Field Safety Notice

SBN-RTD-2019-001

VENTANA HE 600 system: Fluid Leak and Risk of Burnt Components

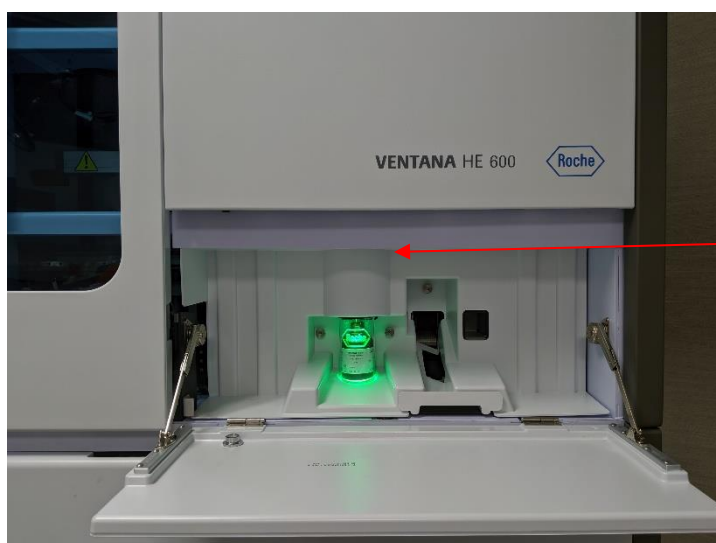
The root cause investigation, including the cause for the Cleaning Solution leak, is on-going and suggests the cause of the event has multiple contributing factors, including the 65 Micron filter and the Stainer Exchange valve assembly in the Cleaning Solution fluidics line.

Local Roche Field Service Engineers will remove the cable that conducts electricity to the Coverslipper Module LED PCBA, proactively replace the Stainer Exchange Valves, and proactively replace the 65 Micron Filters in the

Customers can continue using the instrument as they would normally do. If evidence of droplets on the instrument coverslip module are observed during normal operation, please stop instrument operation, unplug the instrument, and contact your local Roche Service organization, immediately.

If droplets are observed on the top part of the coverslip module, stop instrument operation, unplug instrument, and contact your local Roche Service organization
